**BEFORE HEARING COMMISSIONERS
FOR SELWYN DISTRICT COUNCIL**

Private Plan Change Request
69 (PC69)

**SUMMARY OF HEARING REPORT OF MR HUGH ANTHONY NICHOLSON
ON BEHALF OF SELWYN DISTRICT COUNCIL**

URBAN DESIGN AND LANDSCAPE

Figure 1: PC69 Walkable Catchments

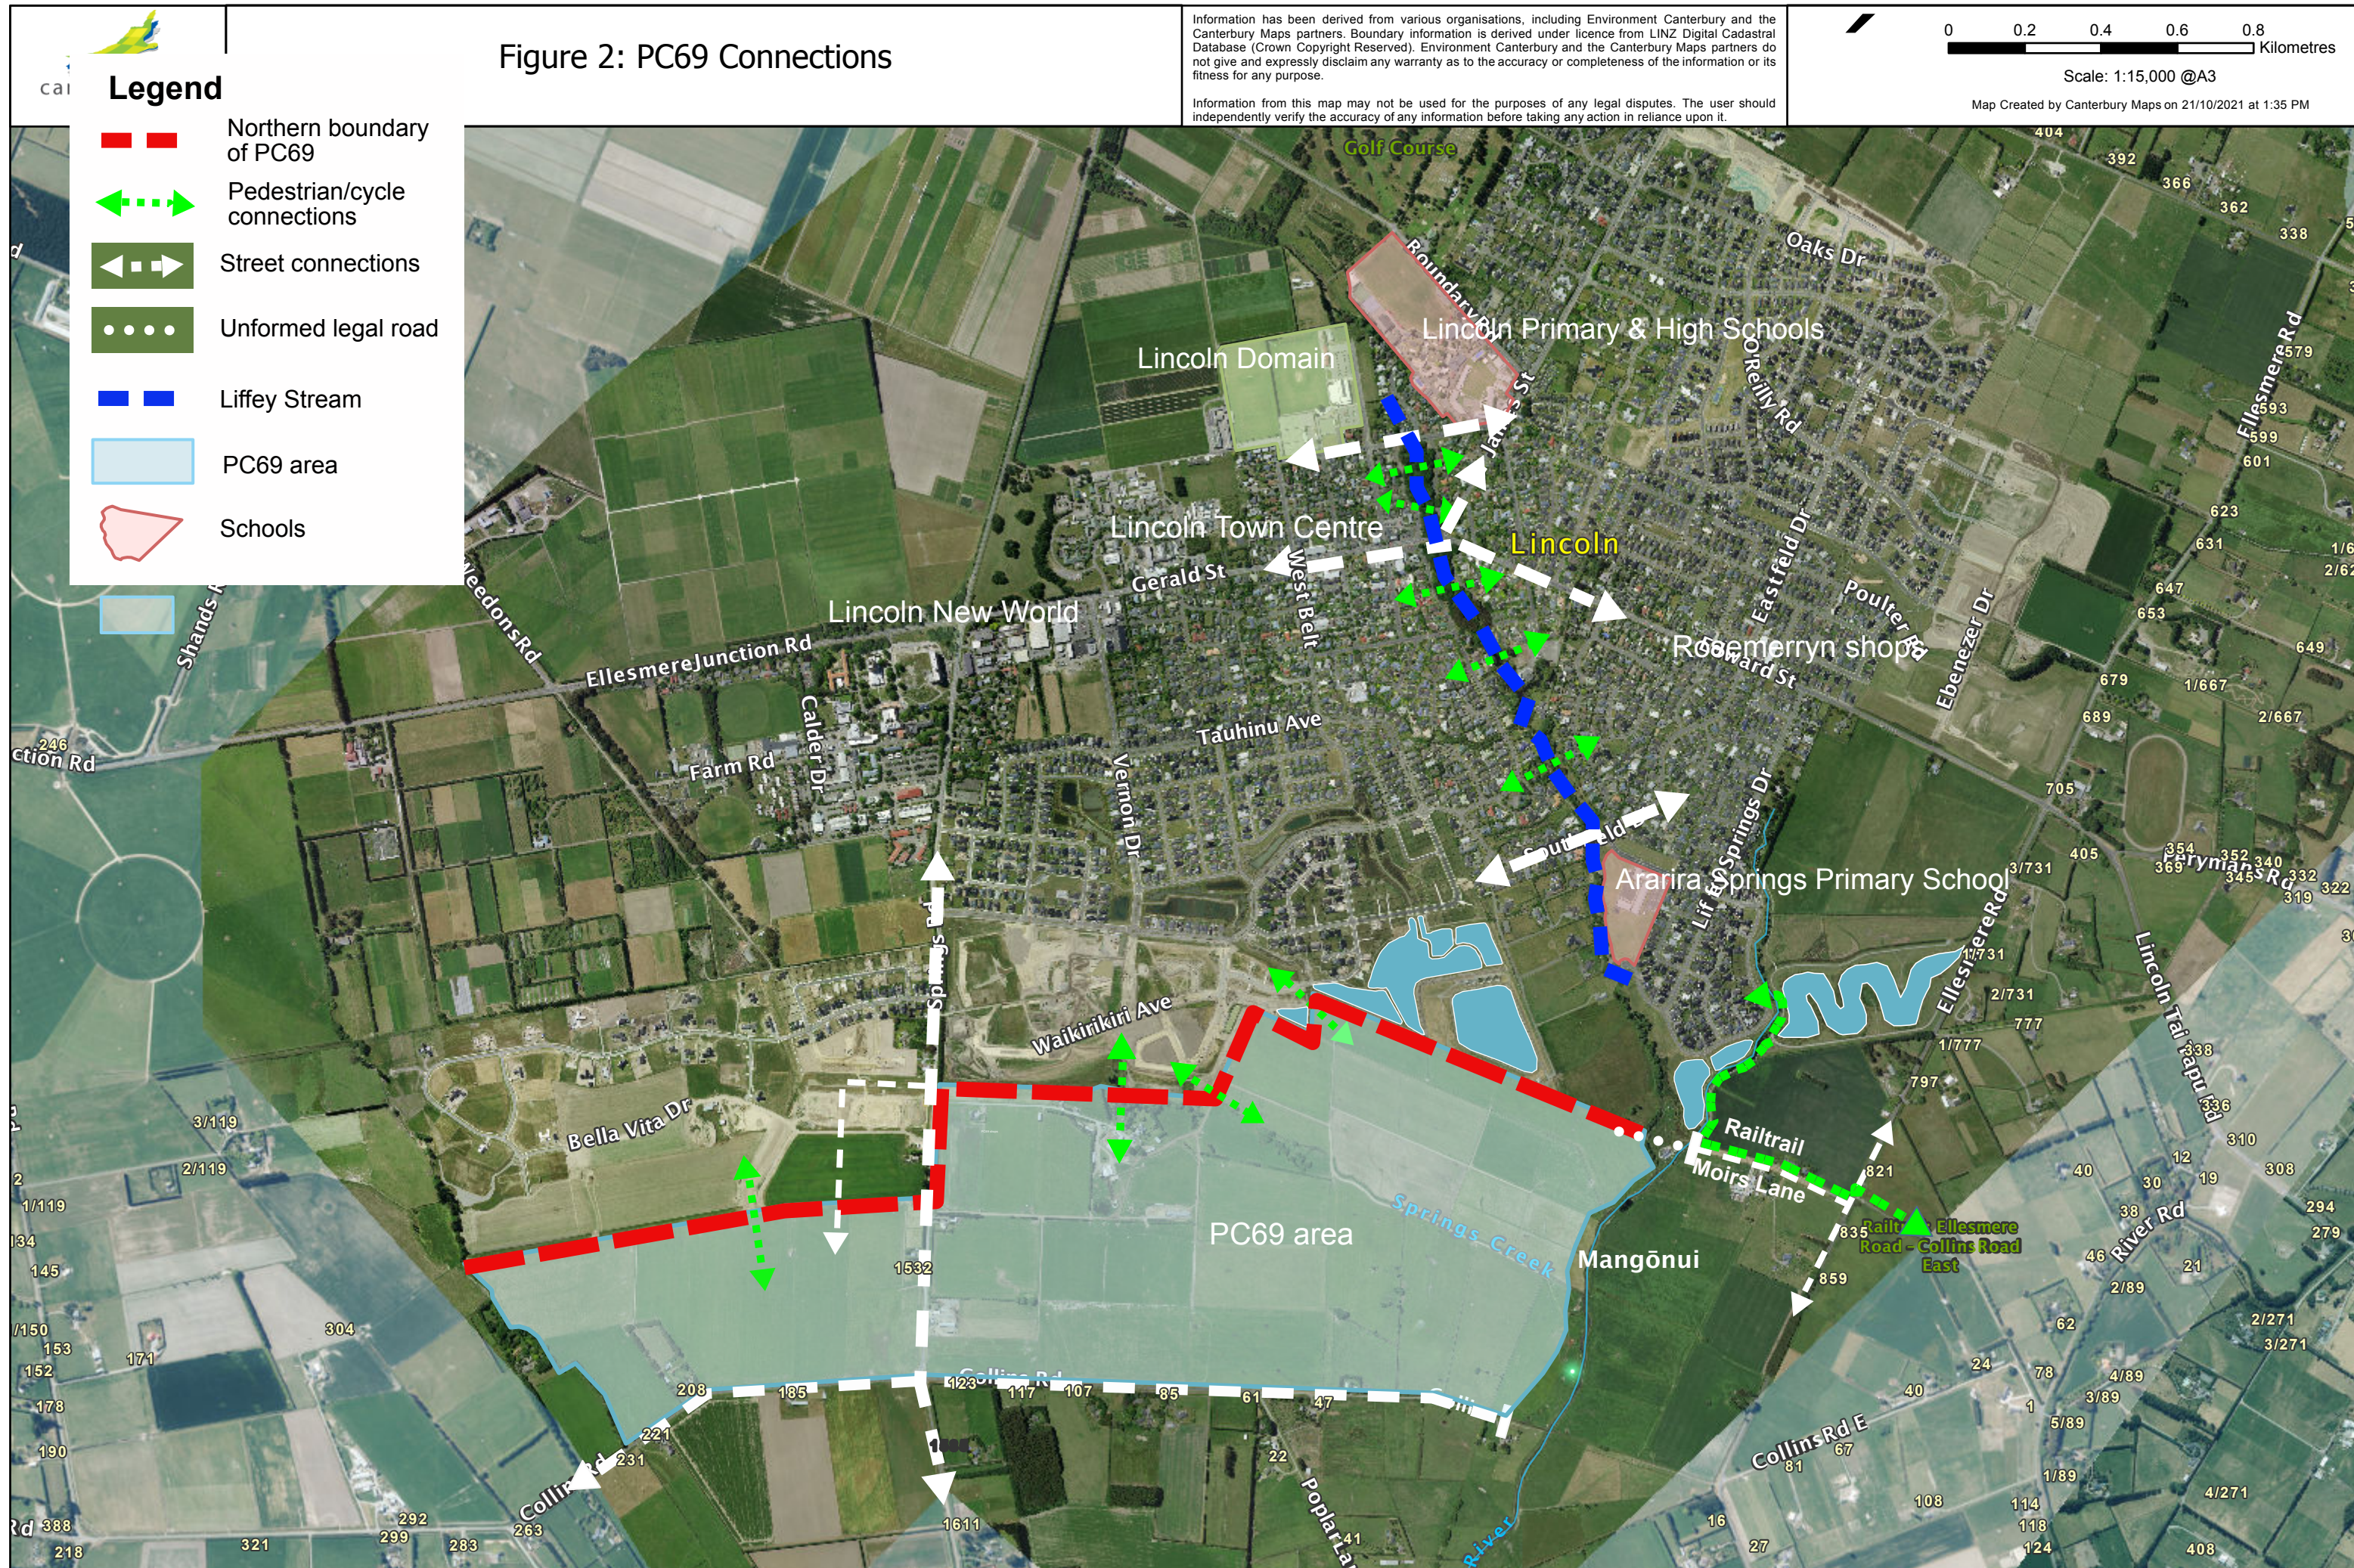
- 3.3 In my opinion PC69 would have poor walkability to most existing public services and facilities in Lincoln. The provision of two additional commercial areas would provide walkable access to local shops for everyday use, however, most of the existing public facilities including libraries, the recreation centre, schools, supermarket and public transport would be more than 1.2 kilometres from the northern boundary of PC69 area plus the internal walking distance within the plan change area (see revised Figure 1).
